# CITY PLAN COMMISSION THURSDAY, OCTOBER 9, 2025

**RECORD NO.:** Plat-25-000093 (S245-237) **SENIOR PLANNER:** Sharmila Shrestha

**REQUEST:** An application replat a 0.684-acre tract of land containing all of Lots 3 and 4 in City Block 1/2230 to create one lot on property located on Empire Drive at Oram Street, northeast corner.

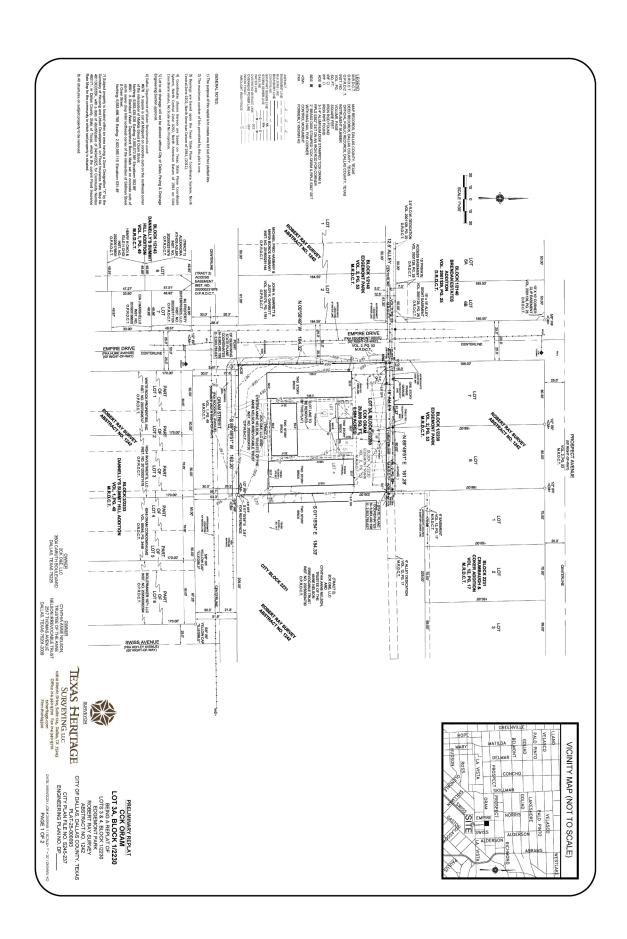
- 23. Additional design information needed to complete review. Provide a brief description of the proposed project and a copy of the site plan to daniel.silva1@dallas.gov to determine street lighting requirements.
- 24. On the final plat, change "Empire Drive (FKA Hume Avenue)" to "Empire Drive (FKA Hume Street)".
- 25. On the final plat, change "Oram Street (FKA Rockwall Avenue)" to "Oram Street (FKA Rockwall Street)".

26.	On the final plat, identify the property as Lot 3A in City Block 1/2230.
